FLOODS

Why AustralianSuper cannot build on Kingswood

**Kevin Poulter President
Save Kingswood Group inc**

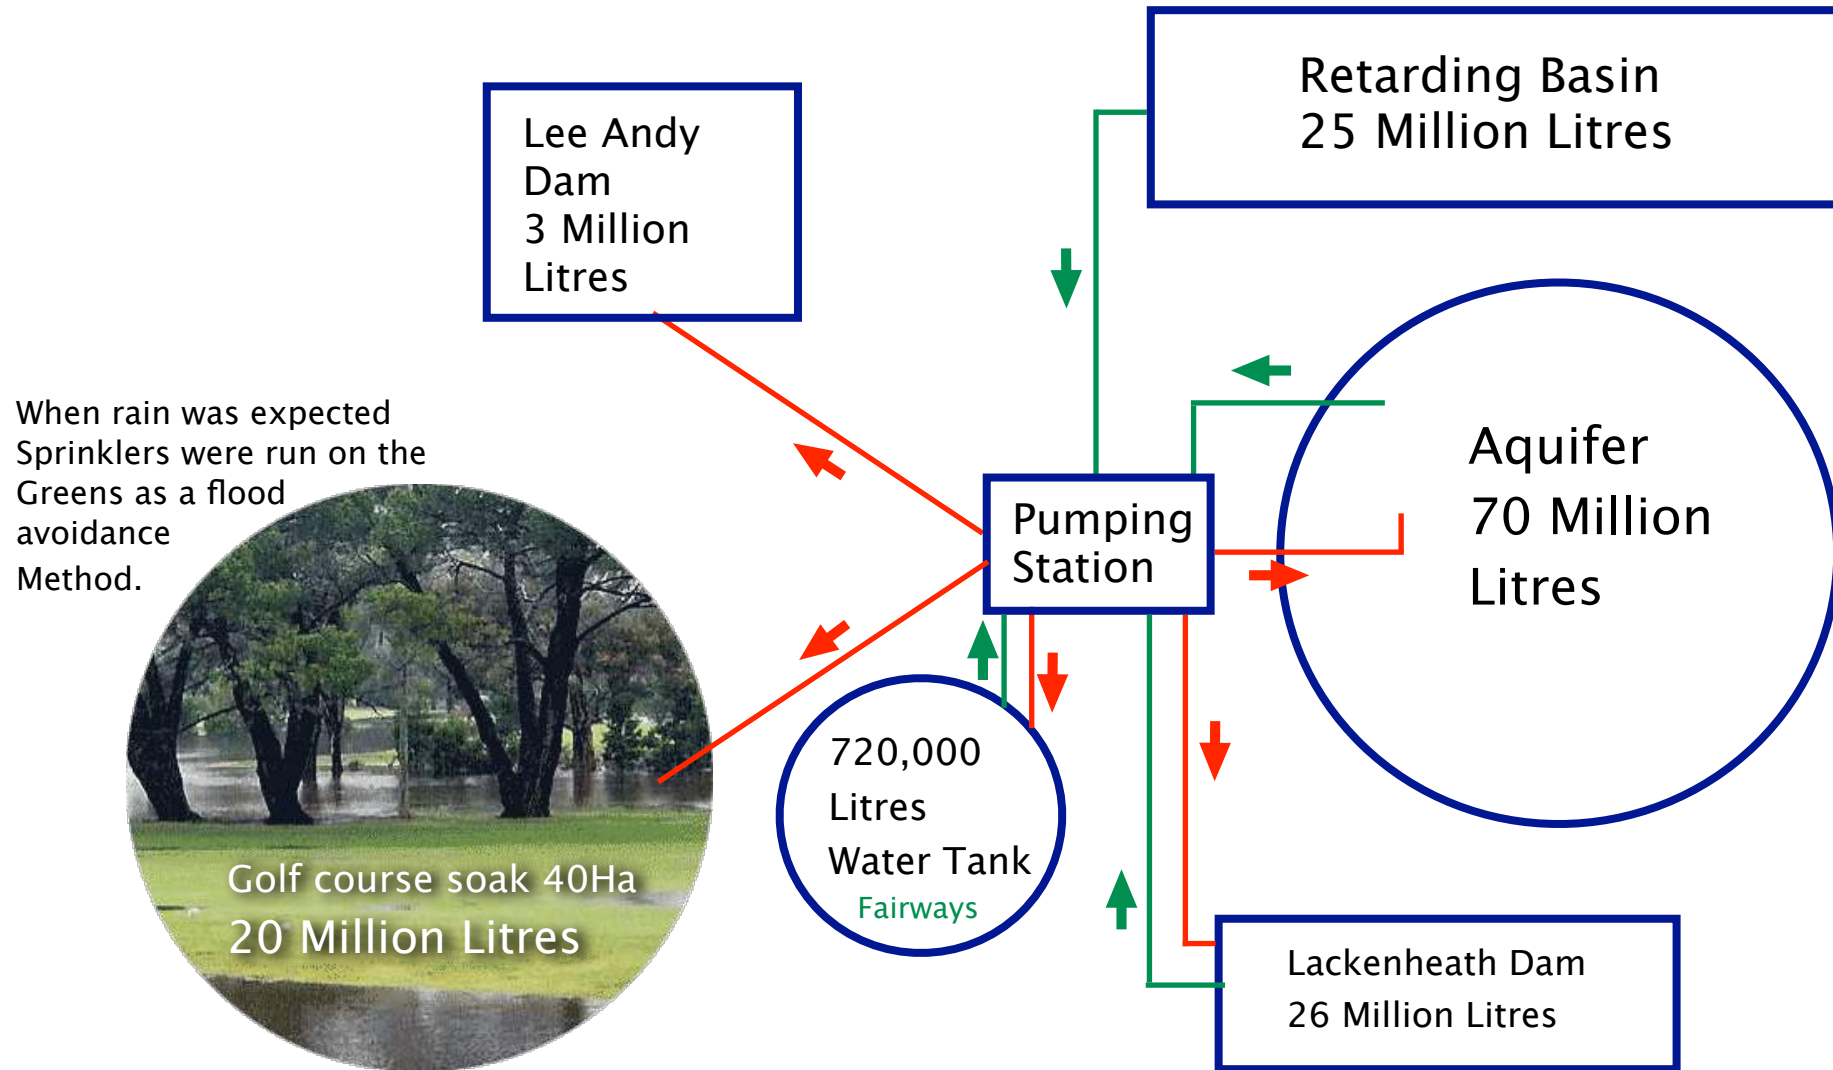
The proponent plans to provide for 64 ML ONLY

In addition, if they follow standard developer's practice, they will dig out the high quality sandy loam and sell it for untold millions,

Replacing it with clay soil that does not readily absorb water, AND building over the massive soak.

So the 184 Million Litres deficiency is conservative, because the sandy loam soak will be destroyed

The Aquifer and Flood control

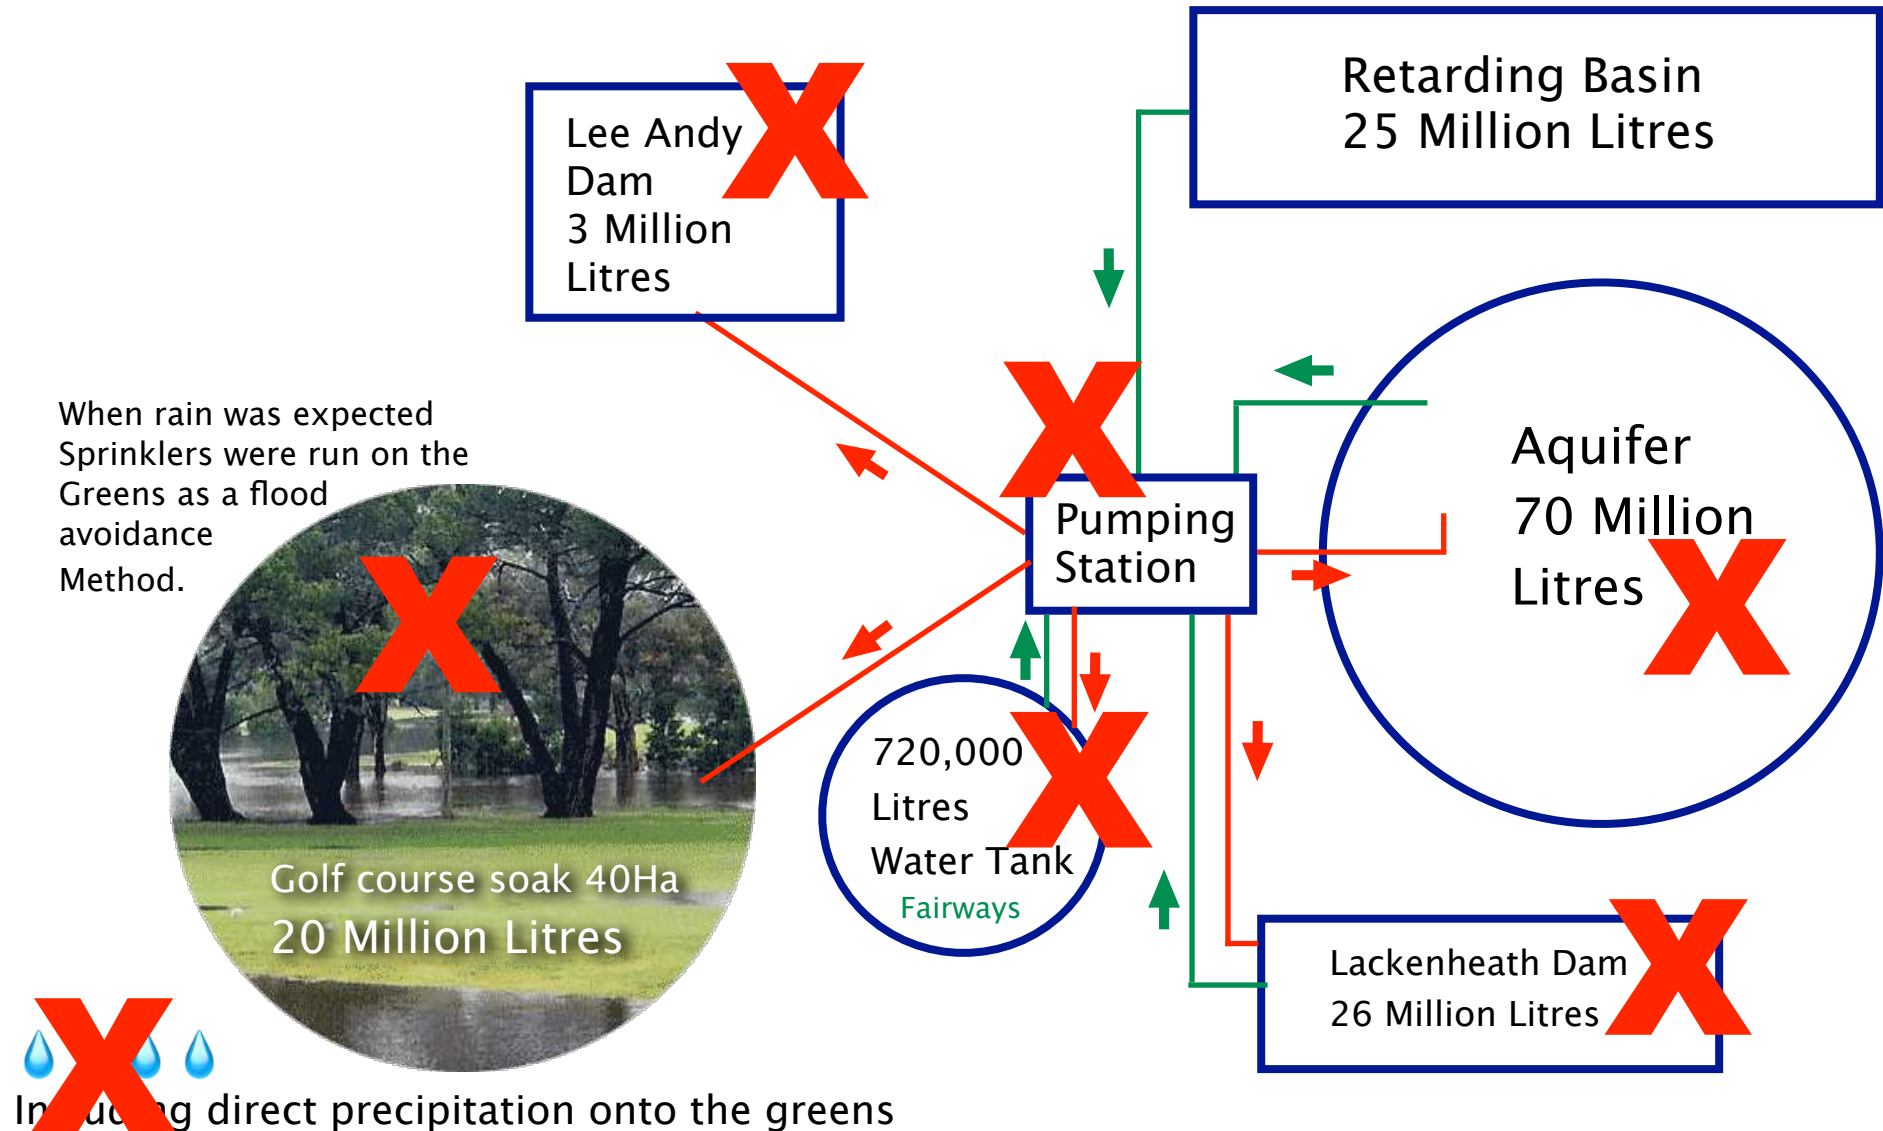
The proponent plans to eliminate as shown

The proponent

- offers no Aquifer, only 64ML of static storage LESS residual level, estimated at say, 40ML
So their flood buffer could be 24ML

The Aquifer offers

A total of 120ML total capacity PLUS the greens soak, less the holdings at any one time.

- “120 Million Litres of storage and aquifer will be bulldozed
– that alone is a greater loss of flood prevention than the proponent offers**
